A	MS	K Ashley
2/21/2011		ECN-149005
RELEASE FOR PRODUCTION

DESCRIPTION:
.050 PITCH TERMINAL ARRAY ASSEMBLY
DWG. NO.
ASP-161073-02
BY:M SOLANO 02-21-2011 SHEET 1 OF 3

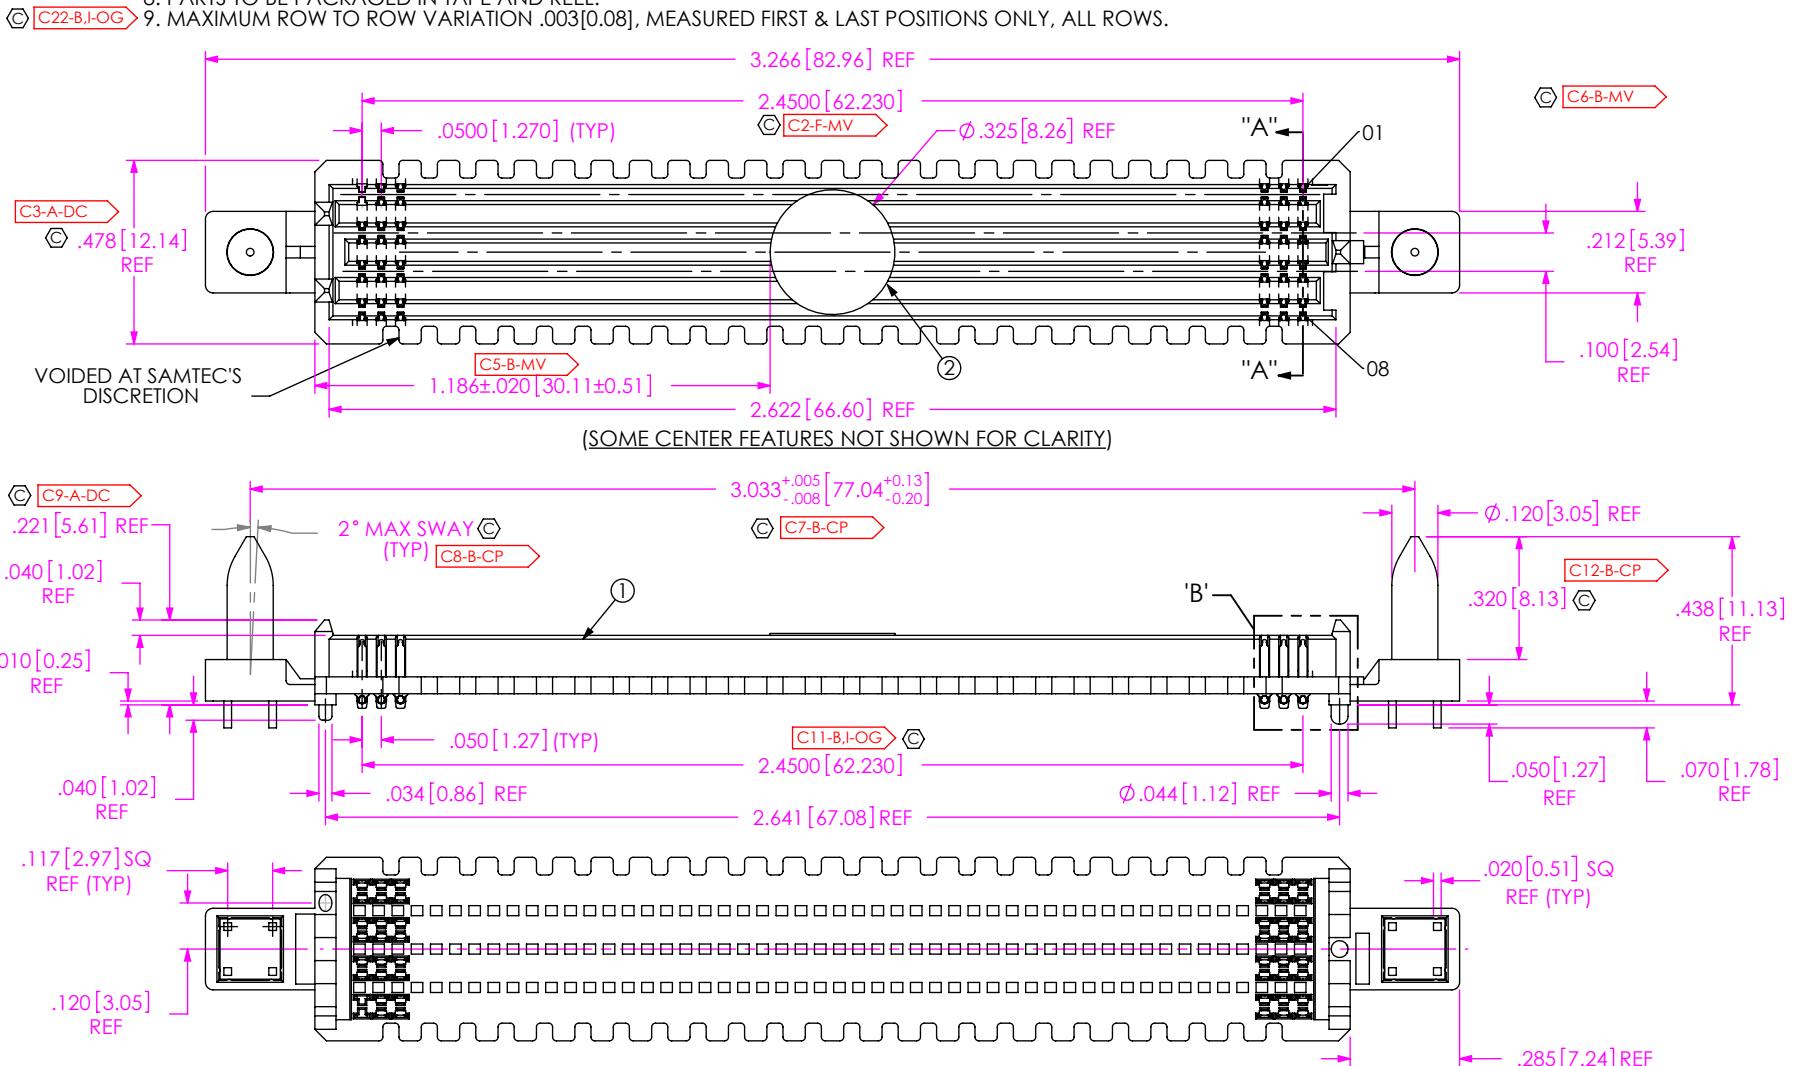
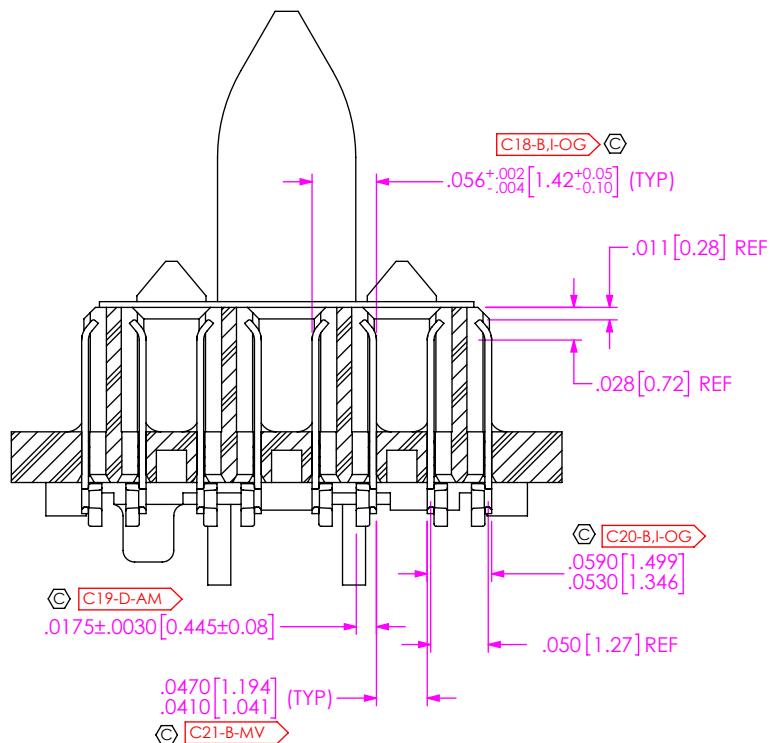
TOP VIEW: CHG 2.450 TO 2.4500, DEL C1, C4, FRONT VIEW: ADD .221 REF, DEL .181 & MOVE C9 TO .221 REF, DEL C10, CHG 2.450 (TYP) TO 2.4500 & CHG C11-F-MV TO C11-B-I-OG CHG .034 TO 034 REF, CHG DIA .044 TO DIA .044 REF, CHG C12-B-MV TO C12-B-CP, DEL .498 REF, ADD .439 REF, BOTTOM VIEW: CHG .000 SQ REF (TYP) TO .020 SQ REF (TYP), MOVE DET 'B' TO SHT 2; NOTES: CHG NOTE 3 FROM "MIN PUSHOUT FORCE: 0.75 LBS" TO "MINIMUM PUSHOUT FORCE: 0.50 LBS", CHG NOTE 4 FROM "DIMENSION TO BE ... FOUR CORNERS" TO "DIMENSION C15 MUST ... FOR PROCESS", DEL NOTE 7 "SOLDER CHARGE VOLUME ...", ADD NOTE 9 & C22, BOM: ITEM 1: CHG MATER FROM 'TERMANL: COPPER ALOY' TO 'TERMANL: COPPER ALOY/LEAD FREE SOLDER', ITEM 4: CHG MATER FROM LABEL TO VINYL, MATERIAL BLOCK: DEL 'SOLDER COMPOSITION ...', SHT 2, SECT 'A': ADD (TYP) TO .056 +/- .002-.004 & CHG C13-F-DE TO C18-B-I-OG, CHG .058 +/- .003 TO .0590/.0530 & CHG C13-F-DE TO C20-B-I-OG, CHG .016 +/- .003 (TYP) TO .0175 +/- .0030 & CHG C13-F-DE TO C19-D-AM, CHG .044 (TYP) TO .0470/.0410 (TYP) & CHG C13-F-DE TO C21-B-MV; DET 'B': DEL .0270 (SEE NOTE 4) & C14, ADD .011 REF, CHG C15-F-OG TO C15-B-I-SG, DEL .000 (SEE NOTE 4) & C16, ADD .002 +/- .003 (SEE NOTE 4 & 9) & C17; ADD CPC INSPECTION TABLE; MOVE RECOMMENDED FOOTPRINT TO SHT 3.
